Burnley Pendle Growth Corridor Junction H Rose Grove Junction

Stage 1 Road Safety Audit

Burnley Pendle Growth Corridor Junction I A670 Active Way / Royle Road Signalised Roundabout

Burnley Pendle Growth Corridor Junction J Active Way / Bank Top Junction & Active Way Pelican

Figure A.2: Existing flag type sign on Royle Road splitter island, requiring mounting at 2.1m

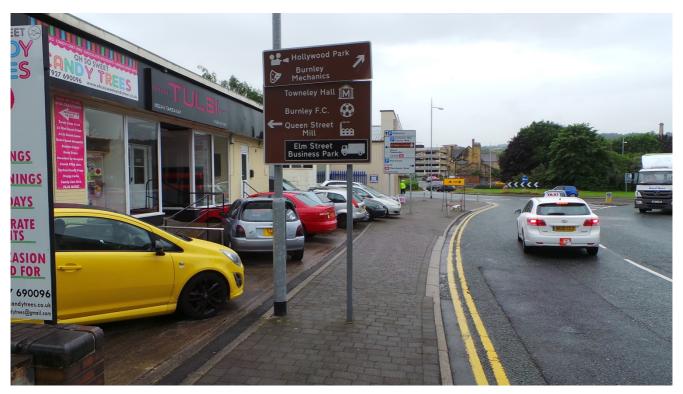
The existing flag type sign located on the northern splitter signing north on Royle Road shall require re-erecting at 2.1m mounting height, to provide unrestricted visibility to pedestrians and motorists.
